Certificate of Appropriateness

Property	210 W. BROWN ST. Brewers Hill Historic District
Description of work	Install Smart Vent on roof near the gutter line for air circulation beneath roof boards. Remove glass block windows in basement and install new wood awning type windows. Install two new double hung windows on east elevation. Rebuild bay window on east elevation consisting of one landscape sash and two flanking double hung windows. Replace bay window on front elevation (south) with a new landscape sash and two flanking double hung windows. Install two new storm windows on south elevation facing the street.
Date issued	8/21/2013 PTS ID 89526 COA, window replacement

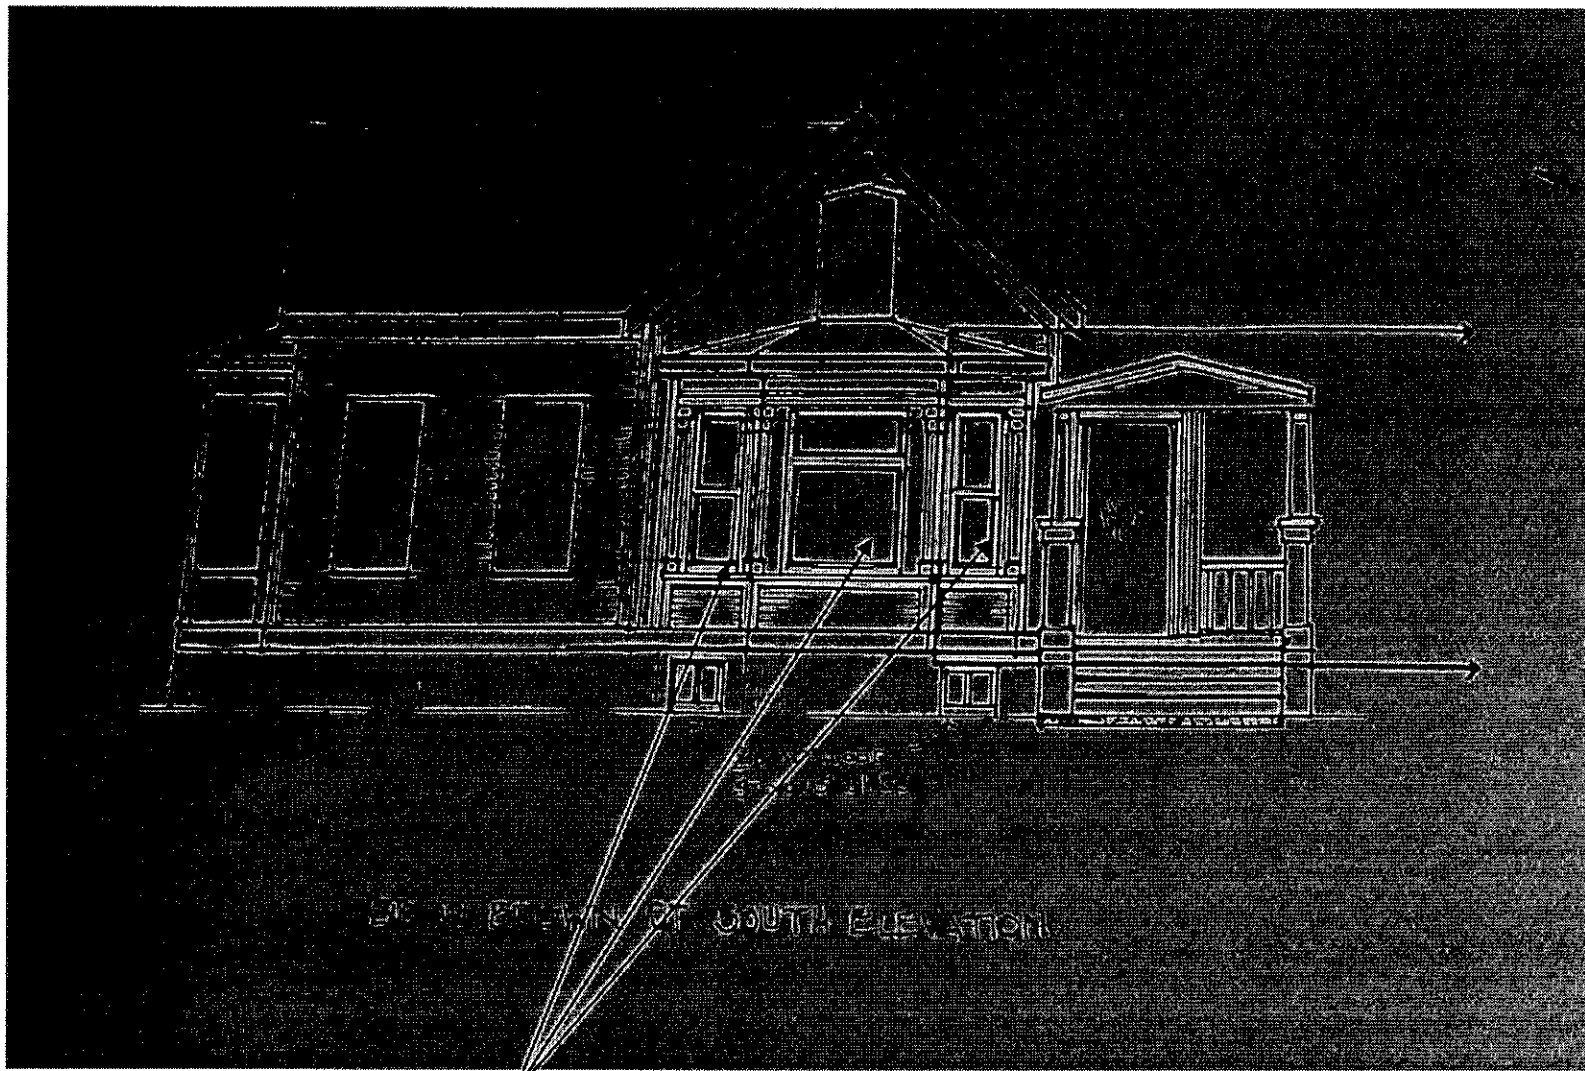
Replacement sash must be double hung, like the originals (casements not allowed) for the large landscape sash window on south and east elevations

**East elevation showing
landscape sash and
four double hung
windows to be replaced
with match all wood
windows.**

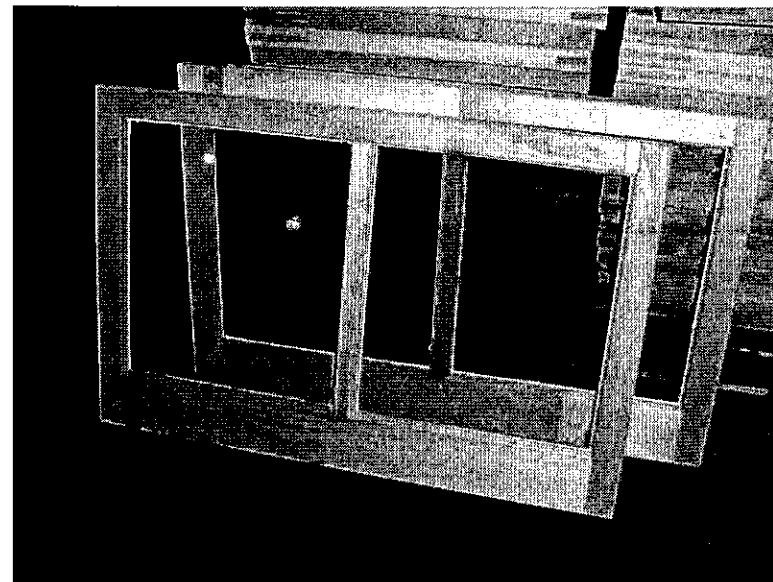
A total of four double hung windows will be replaced on east elevation. New window units must not be installed the existing windows and must be a stud to stud replacement and original glass sizes must be matched. Historic thick sills, 1-3/4" thick must be used per the original windows and the sill ears must be extended so that the side trim board rests on top of them as per the original design

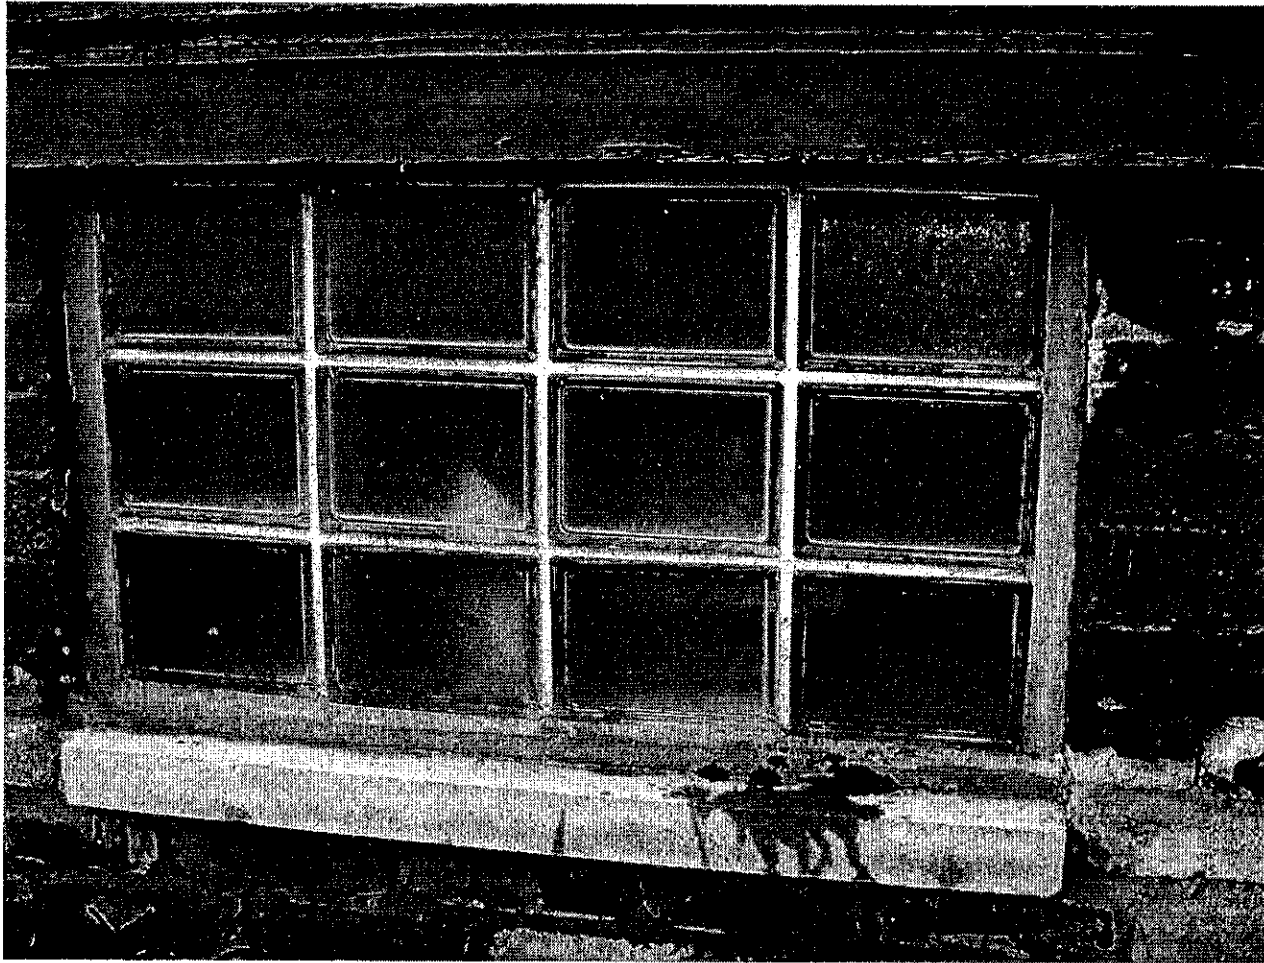
Two existing storm sash in the basement windows on the south elevation will be removed and replaced with new all wood storm sash shown at right

A total of four basement, glass block window units will be removed and replaced with new, all-wood awning style windows to replicate the original wood windows.
